South Texas Project
Unit 2
Docket No. STN 50-499
Response to Request for Additional Information Regarding the
2RE08 Steam Generator Tube Voltage-Based Repair Criteria 90-Day Report

Reference: Letter, M. E. Kanavos to NRC, "2RE08 Steam Generator Tube Voltage-Based Repair Criteria 90-Day Report," dated June 28, 2001 (NOC-AE-01001108)

RESPONSE TO NRC REQUEST FOR ADDITIONAL INFORMATION

Figure 2-1: Comparison of POL Curves Using ODSCC Data

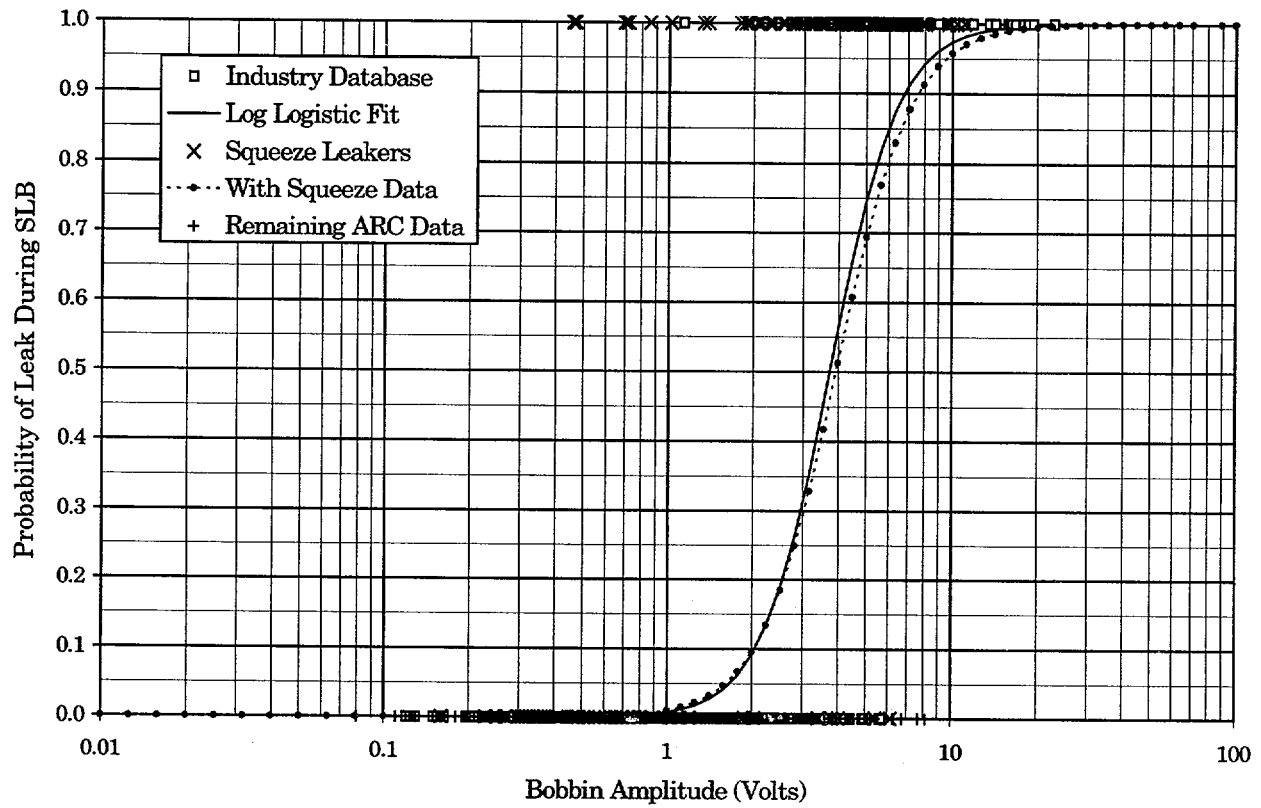
As discussed in Reference 3, operational primary-to-secondary leakage was identified during Cycle 8, and a 600 psi secondary side pressure test was conducted during the subsequent refueling outage to identify possible leaking tubes. The leakage rate under the test conditions was no greater than 1 drop per minute and many tubes did not drip at all rather they were just wet. In Reference 2, 54 tubes with indications above 4 volts were identified as leakers during this pressure test. In addition, in Reference 4, it was indicated that approximately 40 tubes were preventively plugged due to being suspected leaking tubes (presumably these were below the repair limits). During the April 19 meeting, a table listing all of the tubes identified as leakers during the secondary side pressure test was provided along with the voltages for tube support plate indications. Several of these tubes leaked even though the indications in the tube were of relatively small voltages (and the differential pressure during the pressure test was less than would be experienced during a steam line break). Are the results of the secondary side pressure test consistent with the generic probability of leakage model? For the tubes that leaked during the pressure test, please provide a list of any other eddy current indications detected in these tubes (e.g., wear, free span indication, etc.) and address the possibility that these indications were contributing to the leakage.

A very conservative POL evaluation was performed assuming that all tubes implied to be leaking were indeed tubes that would leak during operation, i.e., "squeeze leakers". The remaining indications found during the inspection are considered to be non-leakers. A POL regression analysis was performed using this database and the analysis results were compared to the result using the EPRI generic database of test results. Figure 2-1 illustrates the data and the results of the analysis. The specified squeeze leakers are shown with a POL of 1. The remaining indications used in the ARC analysis are shown as "+" symbols with a POL of 0. The solid line on the figure illustrates the EPRI database solution and the solution using the STP ODSCC data is shown using a dashed line. The results from this analysis support the use of the POL curve

obtained from the generic database. The two curves are in quite good agreement up to bobbin amplitudes of 2 volts. The ARC data beyond that indicate that a POL lower than that of the EPRI generic curve might be expected. A second analysis was initially considered that would assume that only the tubes actually observed to drip during the secondary side pressure test were leakers. However, given the result from the first analysis, the need for the second analysis is obviated, i.e., the match to the generic curve would only be expected to improve or confirm that the generic curve is conservative.
